Serial No.: 10/500,404
Art Unit: 2617

AMENDMENTS TO THE DRAWINGS:

REMARKS

FIG. 2

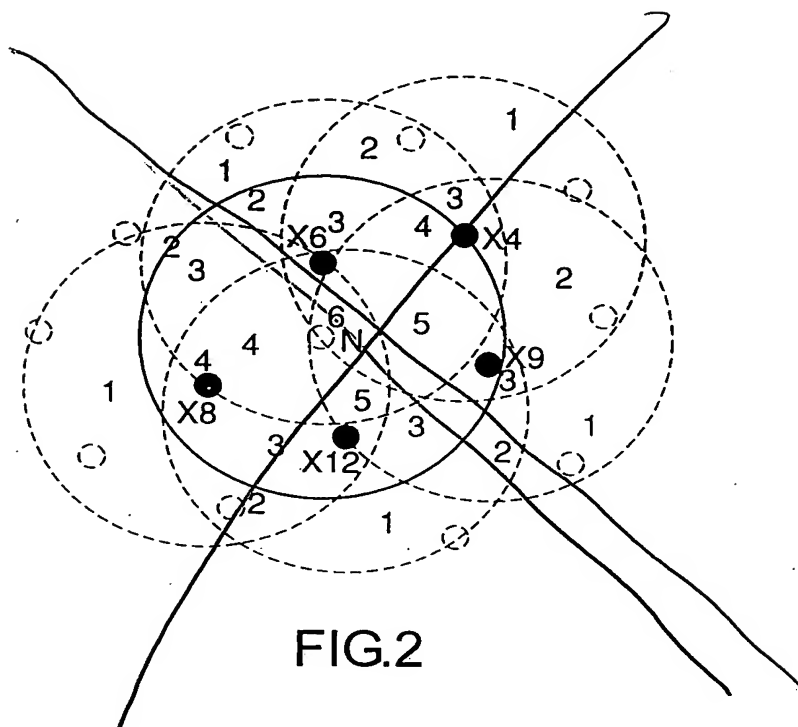
The attached sheet of drawings includes changes to Fig. 2, and replaces the original sheet of drawings. In Fig. 2, the configuration of the nodes has been corrected.

Drawing figure 2 is presented to clarify the relationship of the nodes to the communication nodes with respect to the mobile node. This amendment is supported by page 8, lines 17-21, of the specification, as well as elsewhere in the disclosure. This corrected figure 2 has already been filed in and accepted by the Japanese Patent Office for a counterpart patent application. It is respectfully submitted that no new matter has been added.
